EBeam_Javery – Imbalanced Mach-Zehnder interferometers, TE 1550 nm (final)

Designer: Javery (edX) · GitHub: ChenJavery · File: `submissions/EBeam_Javery.oas` · openEBL-2026-10 · SiEPIC EBeam PDK, KLayout + SiEPIC-Tools 0.5.31

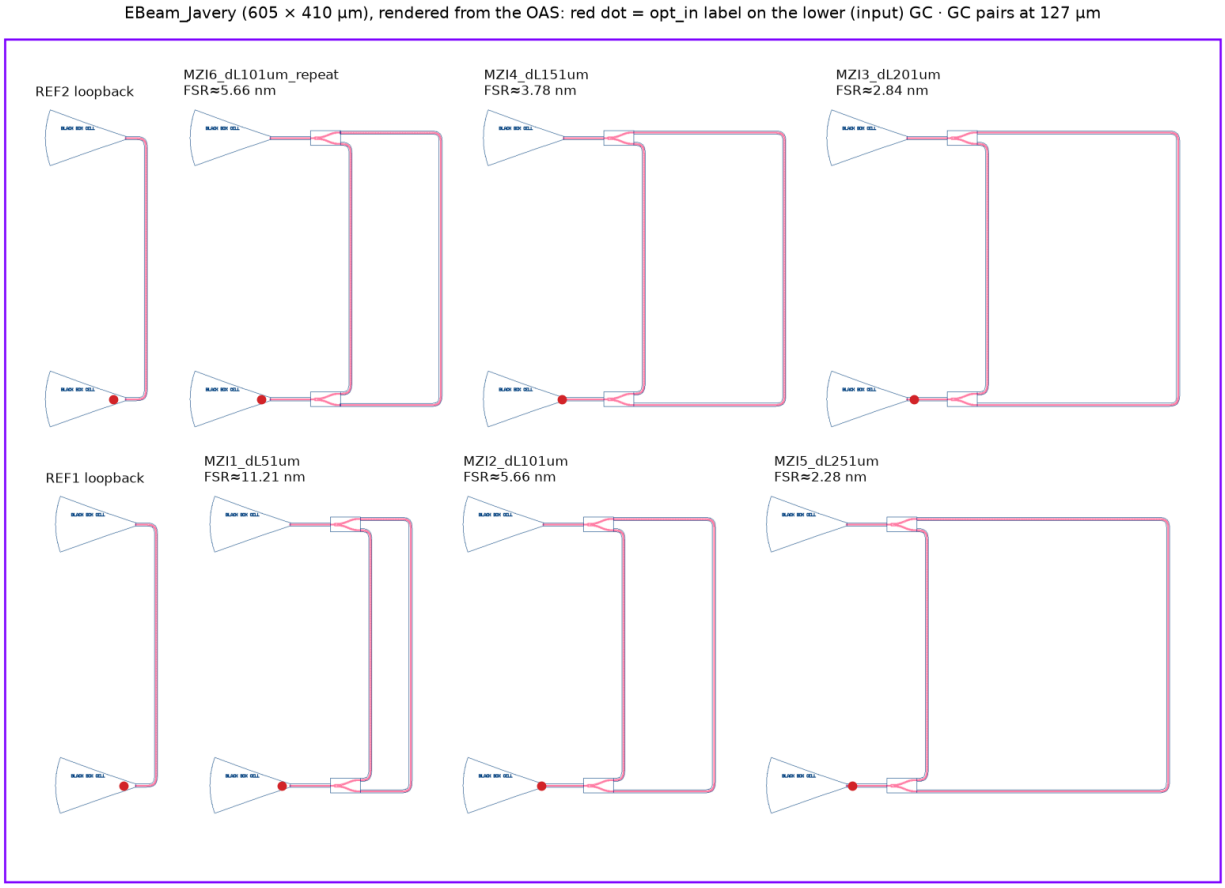
Review point	Draft	Final
Too much empty area	LB + 3 MZIs in the lower half	8 circuits evenly distributed over the full area (added MZI4, MZI5, MZI6, LB2)
Design concept unclear	three MZIs, purpose not stated	explicit goal (n_g extraction), five-point ΔL series, repeat device and two references with stated purpose
Labels unclear	generic labels on the upper GC	label on the 2nd GC from top (input), descriptive names with ΔL, named sub-cells, readable notes
Report not detailed	one page	concept, label table, expected spectra, corners, loss / cross-talk, analysis plan, full checklist
Process variation / loss not addressed	—	MODE corner analysis and loss budget (Sec. 3)
